Roads Department – Planning Report

Register Reference: SD23A/0001 Date: 26-Jan-2023

Development: Construction of a 7 storey hotel building over 2 basement

Location: Site D, Liffey Valley Office Campus, Dublin 22
Applicant: Winmar Developments Unlimited Company

Figure 1 layout

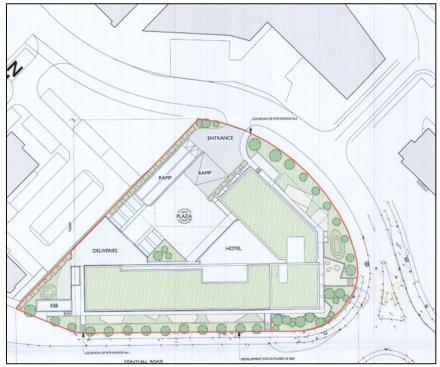
The access will use an existing location on the minor road to the north (LV Motor Hall Road) of the development. There is an existing bus stop on the opposite side of the road at this location. The TII should be contacted to confirm if this stop will be removed.

Vehicles can access the underground parking or the central drop off area. service trucks and refuse collection will use the same access but will be directed to a service year on the west boundary. An autotrack of the refuse and fire tender access has been provided and is sufficient. It is not clear if vehicle access will be required to the ESB substation along the southern boundary.

- 1. Letter of no objection from the NTA.
- 2. Confirmation from the TII that the bus stop/layby opposite to the vehicle access is no longer required and will be removed.
- 3. Clarification of vehicle access to the ESB substation.
